Type of Submission: Notice of Intent	Type of Action: Plug and Abandonment
Date Sundry Submitted: 07/15/2024	Time Sundry Submitted: 01:52
Date proposed operation will begin: 07/29/2024

HILCORP ENERGY COMPANY  
MORTON 1  
P&A NOI

Attachment to notice of Intention to Abandon

BLM - FFO - Geologic Report

**P&A WBD - Proposed Schematic**

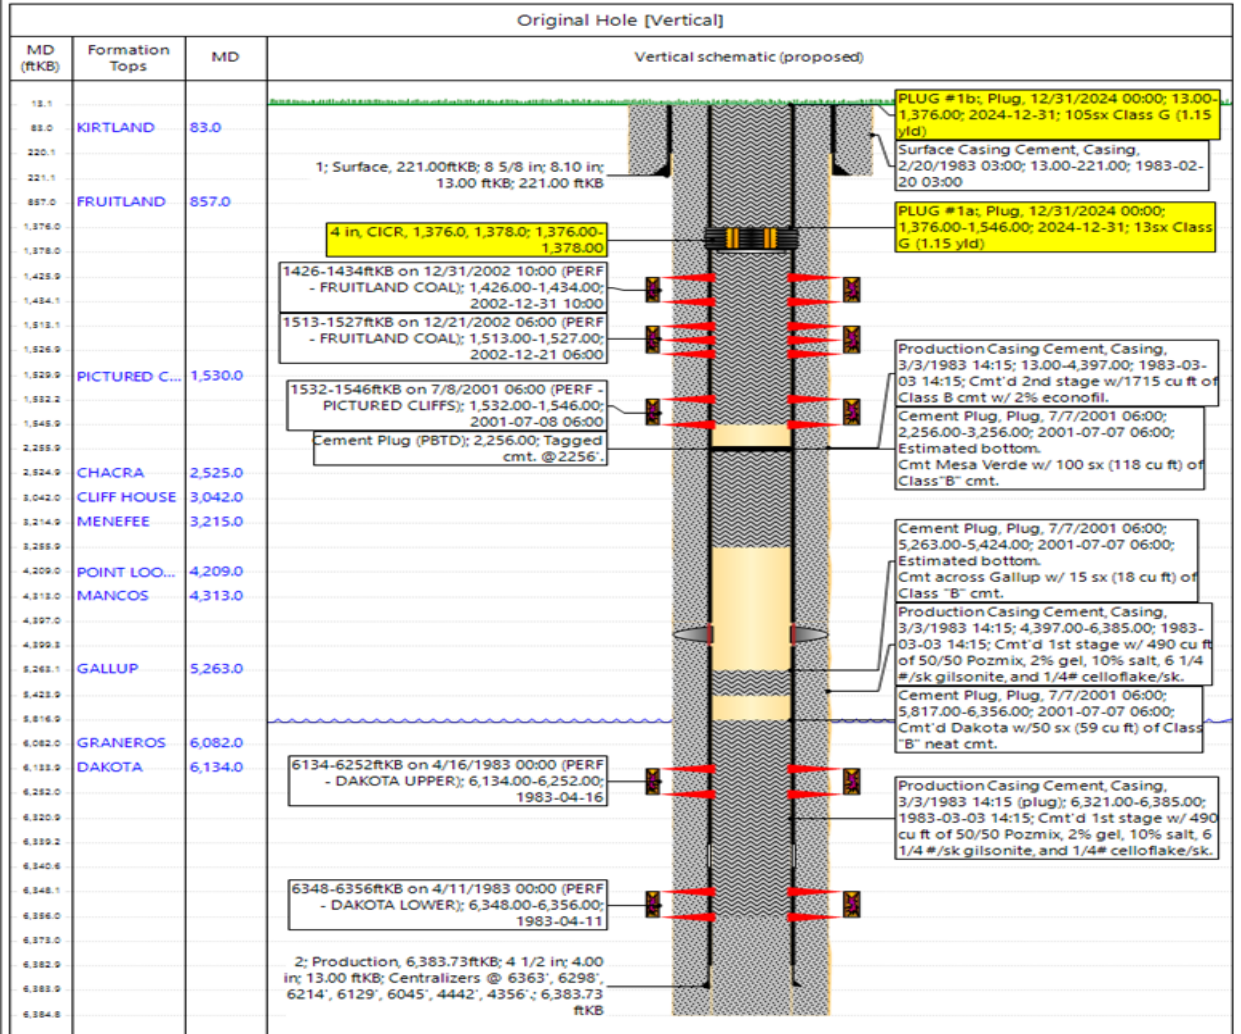
The available raster log supports formation tops selected by the operator. No changes.

Note there are existing plugs below the Pictured Cliffs formation. These plugs are appropriate.

Created By	Condition	Condition Date
mkuehling	NMOCD agrees with Hilcorp on Formation tops - Extend PC plug to 1590 - Notify NMOCD 24 hours prior to moving on Monitor casing strings daily report on subsequent submit all logs prior to subsequent	7/17/2024
